FH12-SV/FH12-SVA Series Product Explanation

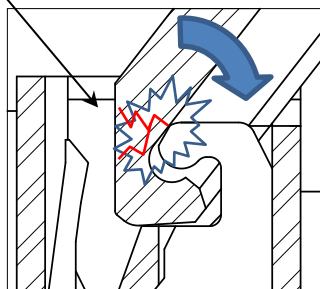
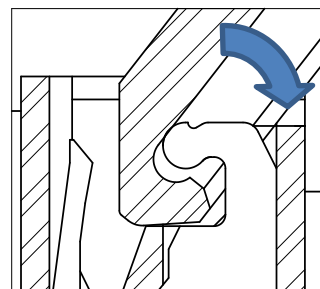
The press matching location of the terminal rotating shaft changed in FH12-SVA (See the illustrations below) (No difference in appearance or dimension).

The press matching location was changed in FH12-SVA, and the sliding part with the actuator was changed to a round form, which realized smoother rotation.

The rotational centers of the terminal and the actuator become misaligned.

The terminal and the actuator hit each other, preventing rotation; if operation is continued, the actuator will be damaged.

Rotation of the actuator will not be structurally prevented if the rotational centers of the terminal and the actuator become misaligned.
